SERVICE CAMPAIGN BULLETIN

CAMPAIGN REF : 015

TITLE : Fitment of Cobra Tracker RF aerial extension to left hand drive vehicles

DOCUMENT # : 11 Q 002

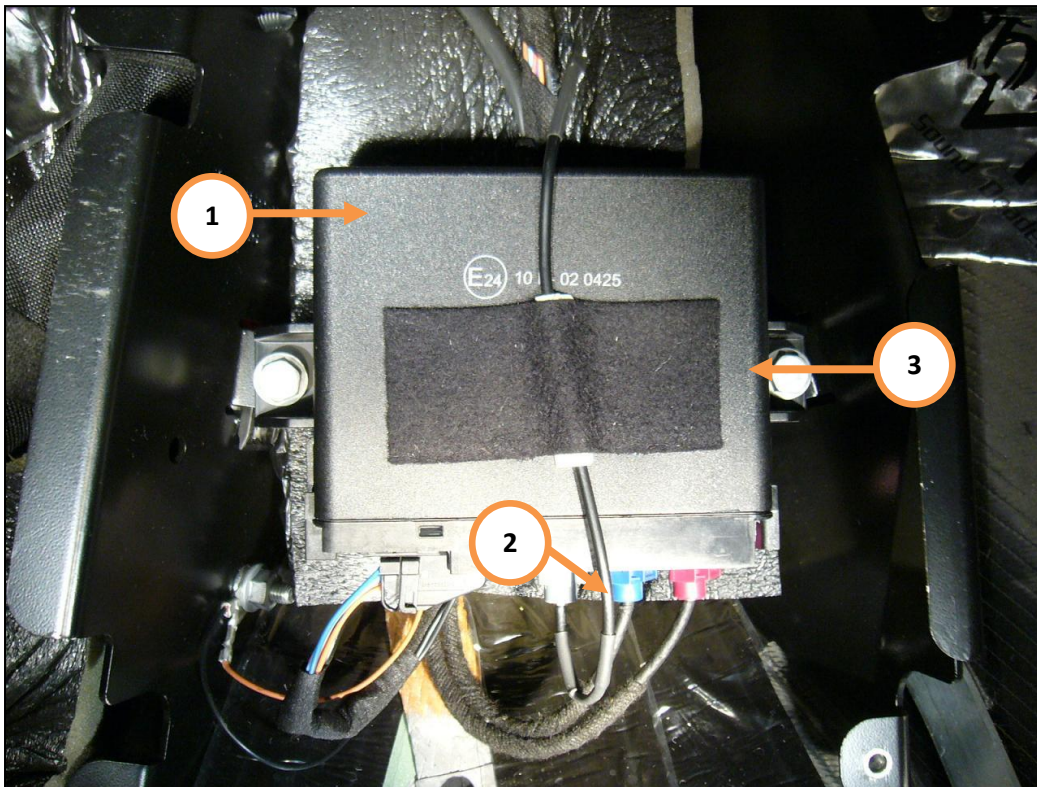
SITUATION : Quality Engineering at McLaren Automotive have identified that an incorrectly routed RF antenna can lead to erroneous Cobra Tracker faults.

PROCEDURE : It is necessary to attach an extension cable to the RF Antenna and perform the following rework:

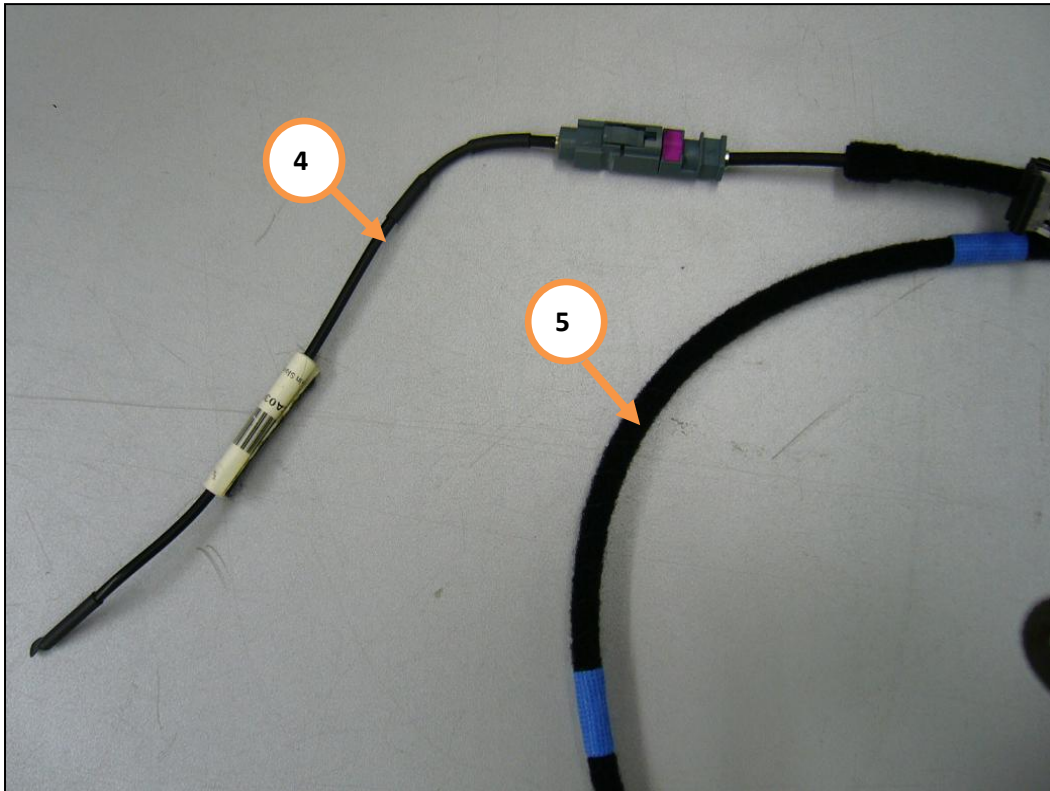
1. The existing Cobra Tracker Module (1) RF antenna (2) and felt tape (3) are fitted to the vehicle as shown:

2. Remove the RF antenna and felt tape as shown. At this point remove the Cobra Tracker unit.

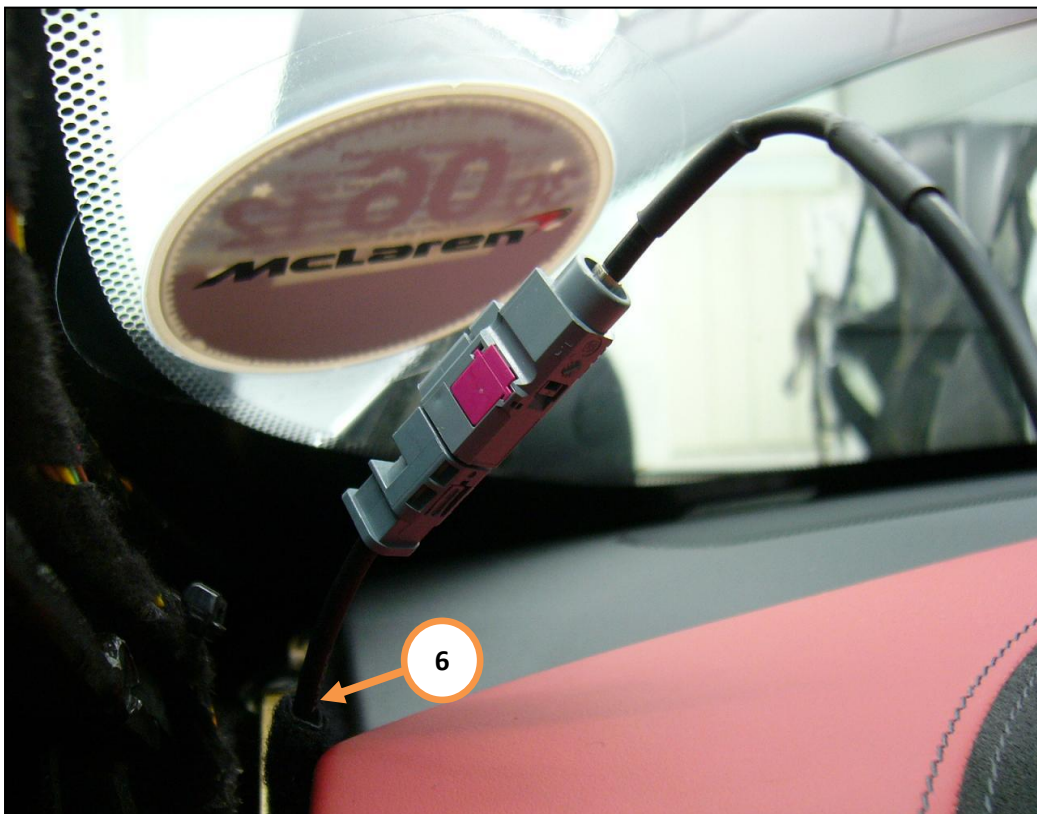
3. Fit original RF antenna (4) from the Cobra Tracker module to the new Extension cable (5).

Care point: The original RF antenna should be threaded in first.

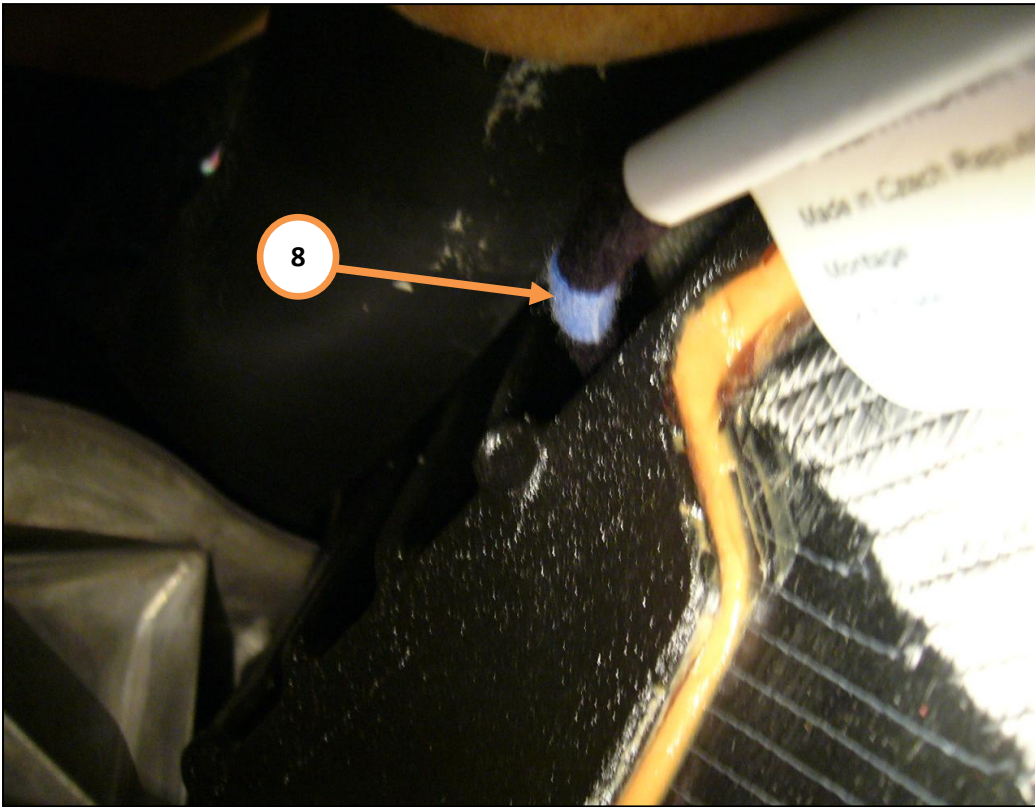
4. Thread the extension cable between the A-Pillar casting and the fascia (6).

5. Wrap the inline connection with Felt Tape (7) to prevent noise and vibration issues by rattling against the A-Pillar.

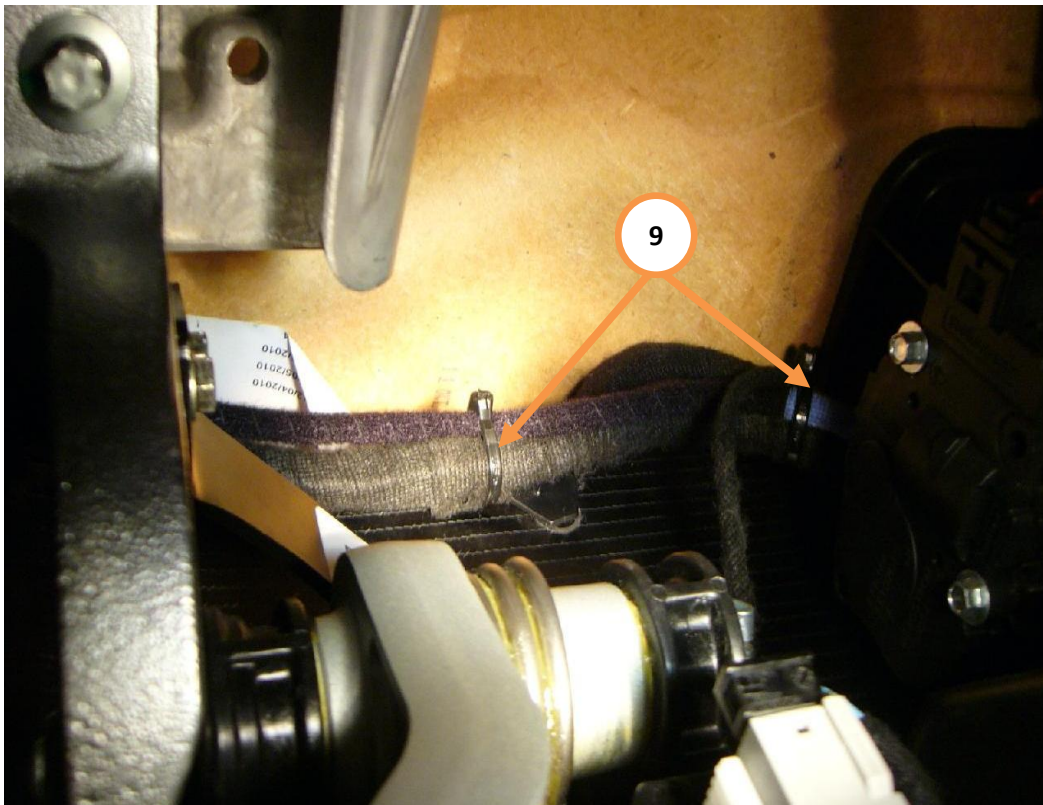
8. Working under the facia pull the extension cable through until the label and blue band (8) are visible.

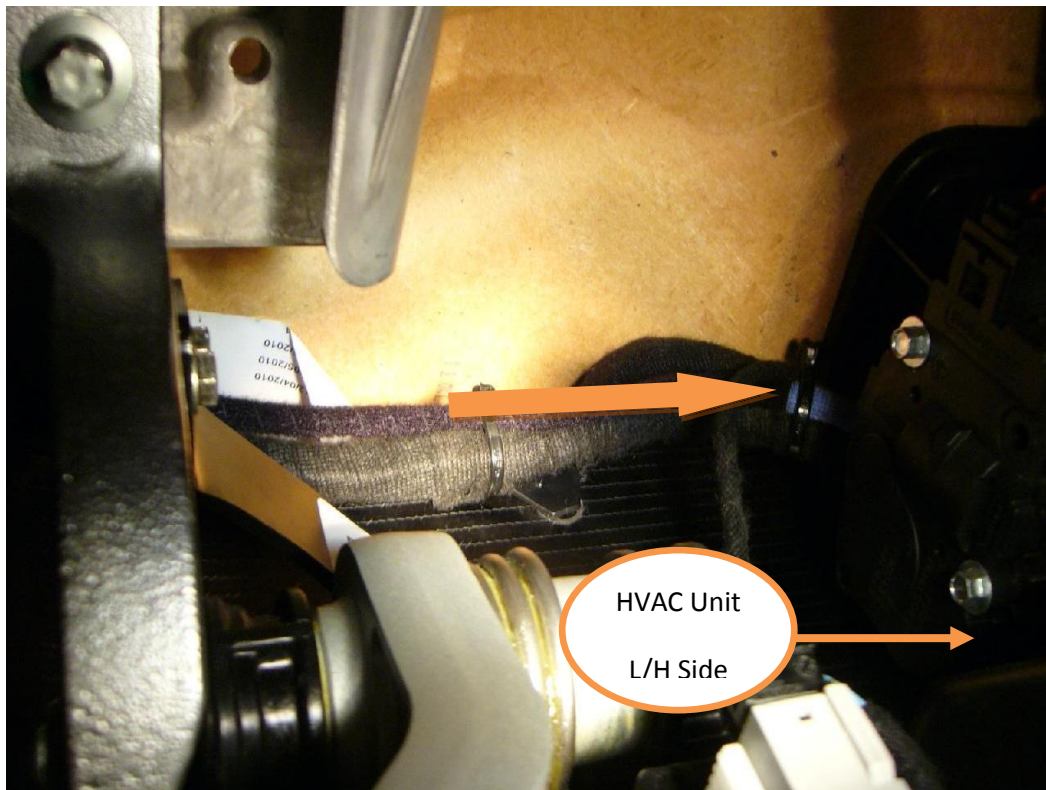
9. Tie wrap extension cable to the main body harness (9).

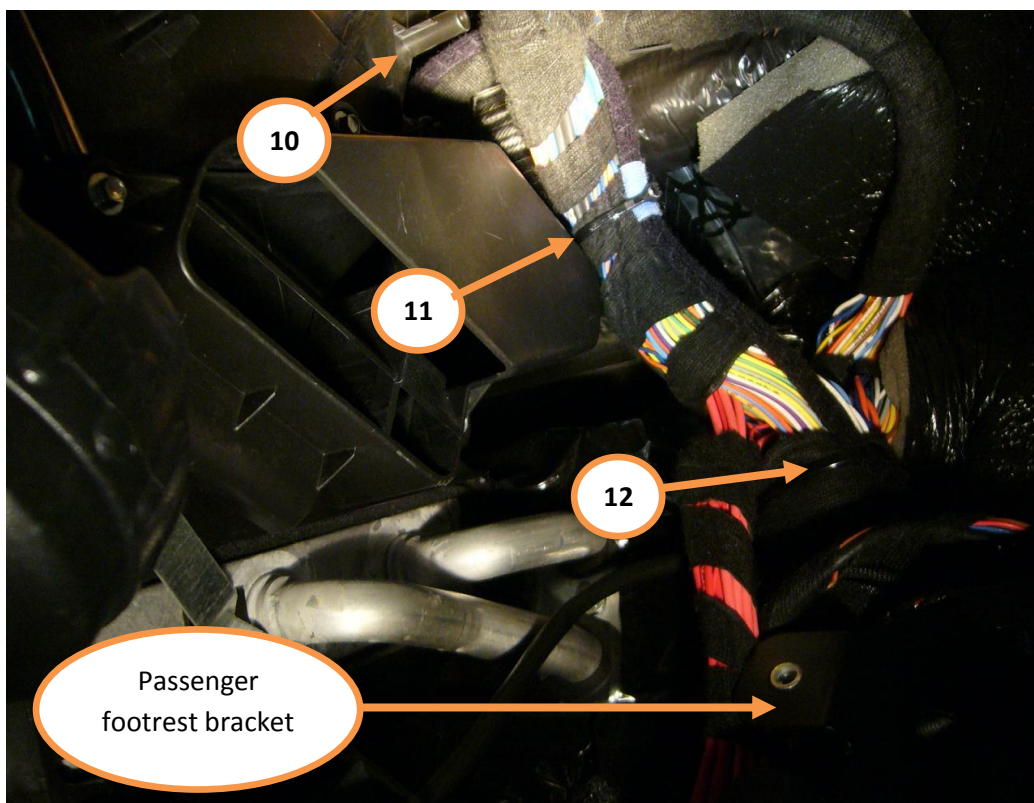
10. Pass extension cable over the left hand side of the HVAC unit following the main body of the direction of the arrow.

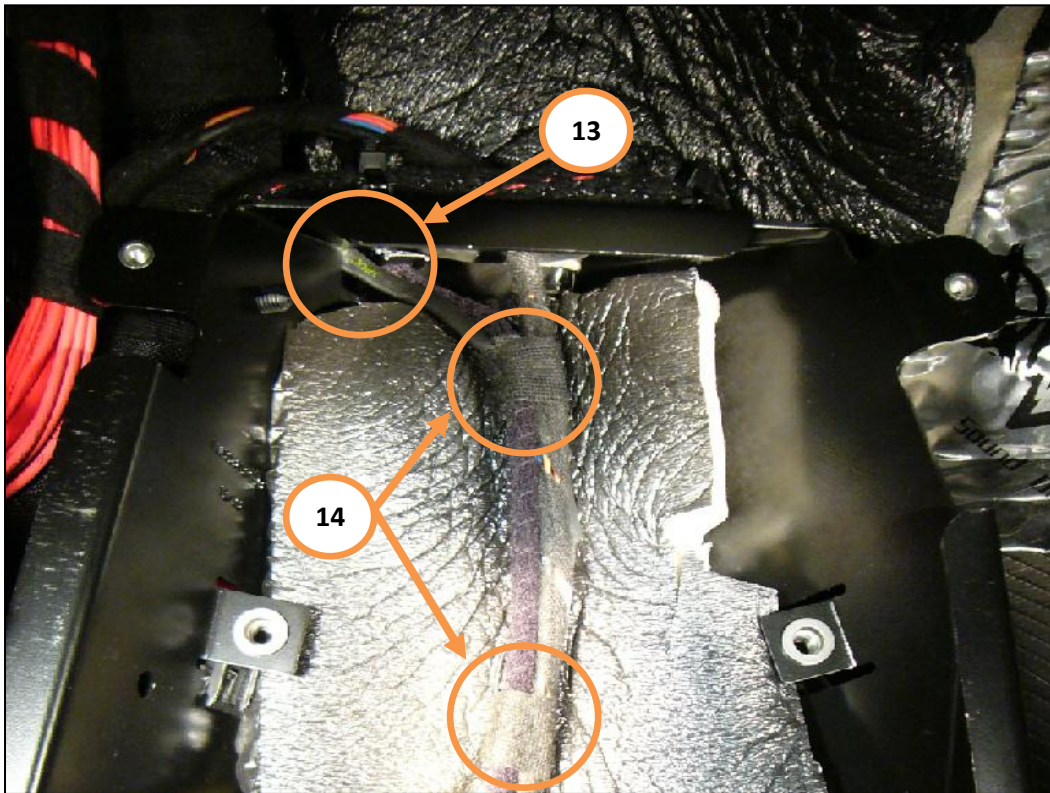
11. Retrieve antenna extension from the right hand side of the HVAC unit (10). Tie wrap antenna extension to the main body harness around the blue band (11) then route the antenna extension towards the passenger foot rest bracket following the main body harness (12).

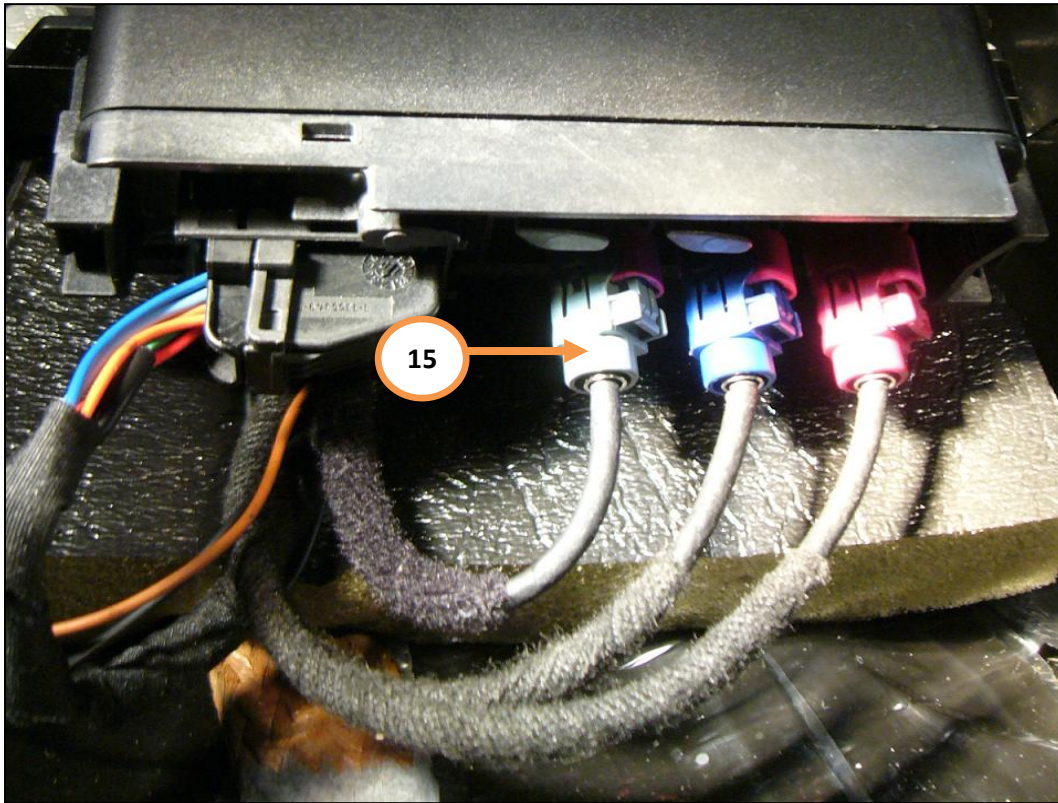
12. Clip the antenna extension to the passenger footrest bracket using the edge clip supplied on the cable (13).
Spot tape the antenna extension cable to the main body harness using 19 mm Fleece tape (14).

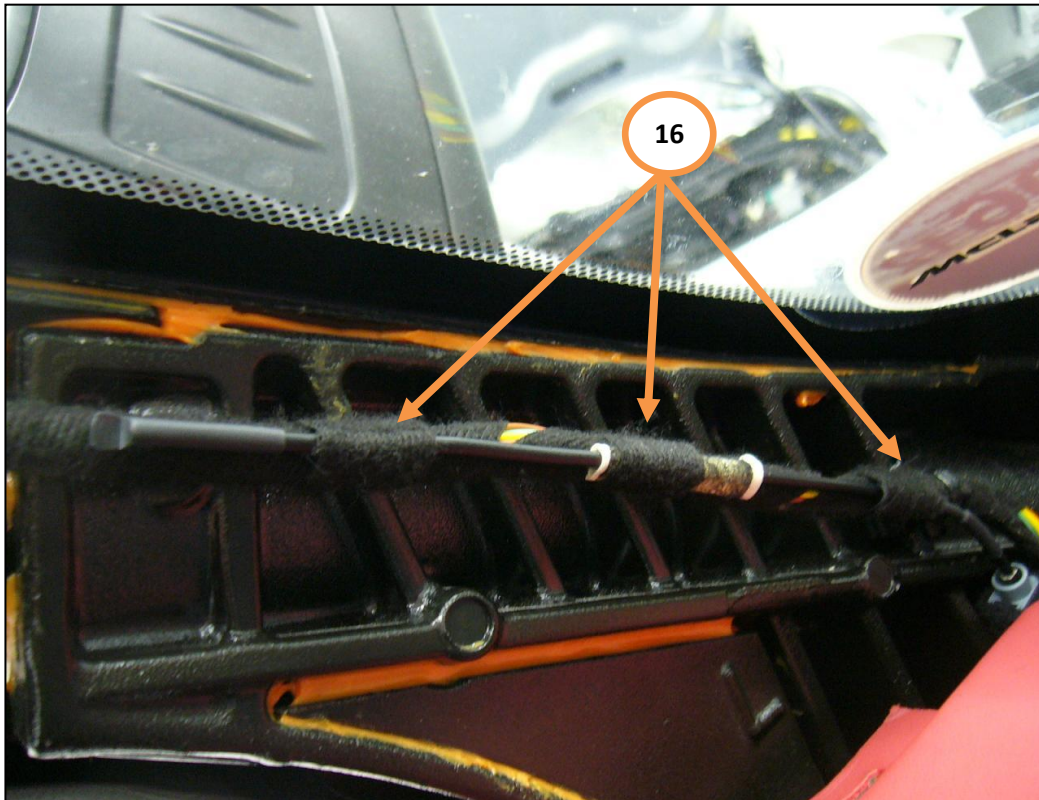
13. Re-fit tracker module ensuring that the fixings are tightened to 6 Nm. The new antenna extension fits into the Tracker Module as shown (15).

14. Spot tape the original RF antenna to the roof harness using 19 mm fleece tape (16).
